Clarification Note # 1

Request for Quotation No. PR 352855 - Supply and Delivery of Equipment for Standalone Diesel Generator and Providing of Associated Services on System Installation

AVR_2 **AVR** ABB S263 B40

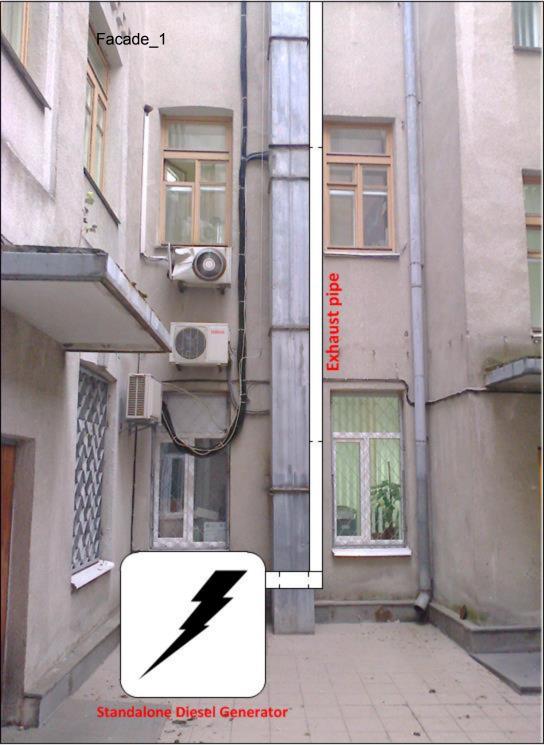
Question 4: What kinds of power box and automation switch are needed?

Answer 4: The AVR shall be placed next to the existing power box inside of the OSCE PCU office, please see below provided scheme (AVR_1). The AVR shall be connected to the ABB S263 B40 Circuit Breaker, please see below provided scheme (AVR_2), thus no power box and automation needed. Distance between Standalone Diesel Generator and AVR: approximately 15 Meters.
